Product Announcement

Thicker Shoe Used on Band Brake Assembly

Manaras-Opera Improves It's Band Brake Assembly

BRAKEPART 019 on Opera-SH >>>

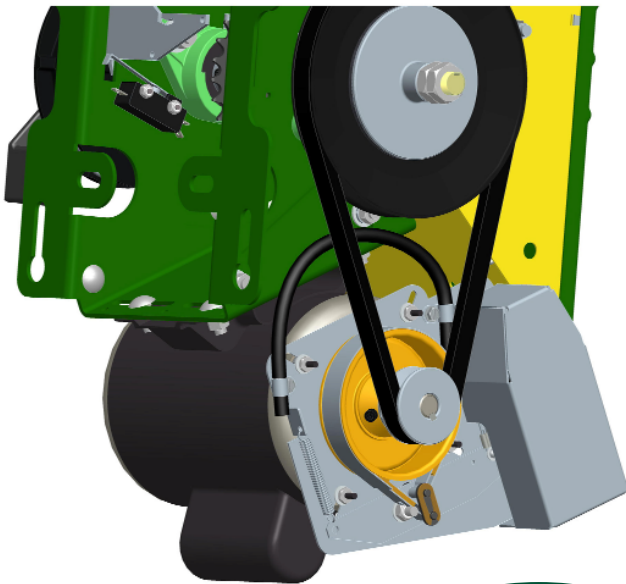
- A thicker metal band **SHOE 026** is being used to support the fiber brake band in our brake assembly **BRAKEPART 019**.
- Improving to **SHOE 026** increases the life span of the brake band, as well as increases the time between maintenance adjustments or component replacements.
- Please note that the replacement component **BRAKEPART 019** replaces **BRAKEPART 017** in the above mentioned assemblies as well as for replacement components.

close up
front view

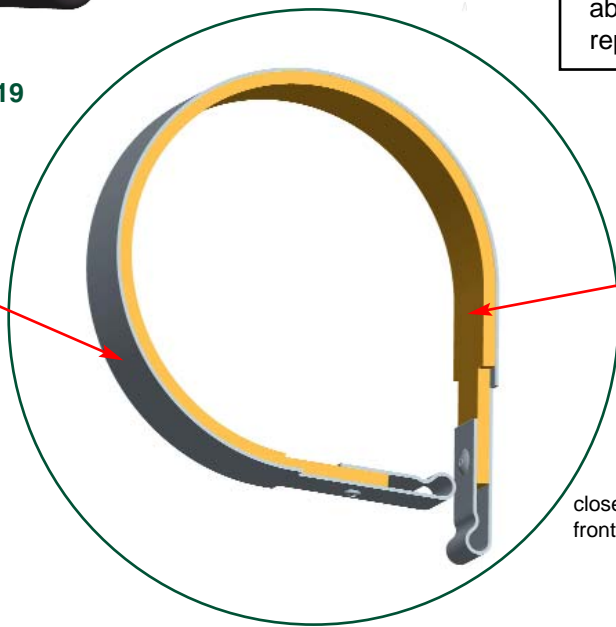
SHOE 026
Thicker metal
band is used

Fiber brake
band
